SUNDRY NOTICES AND REPORTS ON WELLS

1. Type of Well <input checked="" type="checkbox"/> Oil Well <input type="checkbox"/> Gas Well <input type="checkbox"/> Other		MAY 16 2013		5. Lease Serial No. NMNM122622 BHL
2. Name of Operator EOG Resources, Inc.				6. If Indian, Allottee or Tribe Name
3a. Address P.O. Box 2267 Midland, TX 79702		3b. Phone No. (include area code) 432-686-3689		7. If Unit or CA/Agreement, Name and/or No.
4. Location of Well (Footage, Sec., T., R., M., or Survey Description) 330' FSL & 395' FWL, Lot 4 (SWNW), Sec 36, T26S, R33E SHL 230' FNL & 502' FWL, U/L D (NWNW), Sec 25, T26S, R33E BHL				8. Well Name and No. Endurance 36 State Com 4H
				9. API Well No. 30-025-41084
				10. Field and Pool, or Exploratory Area Red Hills; BS Upper Shale
				11. County or Parish, State Lea NM

EOG Resources requests a variance to drill this well using a co-flex line between the BOP and the choke manifold (instead of using a 4" OD steel line).

Internal Hydrostatic Test Graph

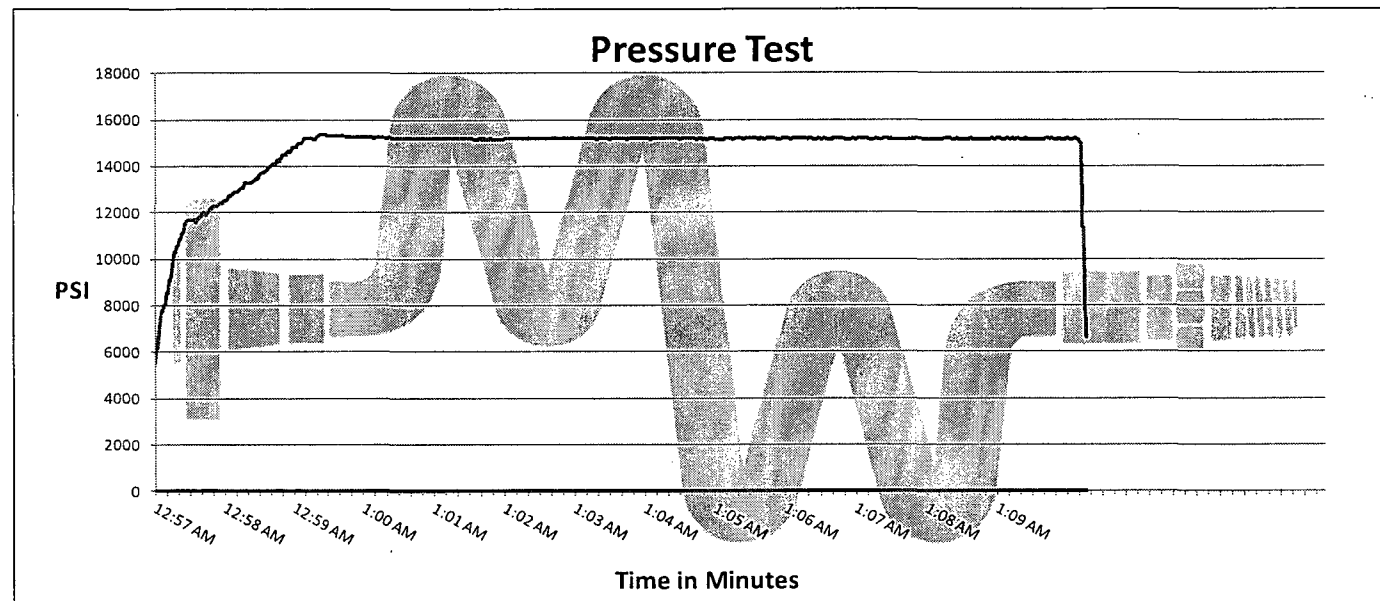
Variance approved to use flex line from BOP to choke manifold. Check condition of flexible line from BOP to choke manifold, replace if exterior is damaged or if line fails test. Line to be as straight as possible with no hard bends and is to be anchored according to Manufacturer's requirements. The flexible hose can be exchanged with a hose of equal size and equal or greater pressure rating. **Anchor requirements, specification sheet and hydrostatic pressure test certification matching the hose in service, to be onsite for review.** If the BLM inspector questions the straightness of the hose, a BLM engineer will be contacted and will review in the field or via picture supplied by inspector to determine if changes are required (operator shall expect delays if this occurs).
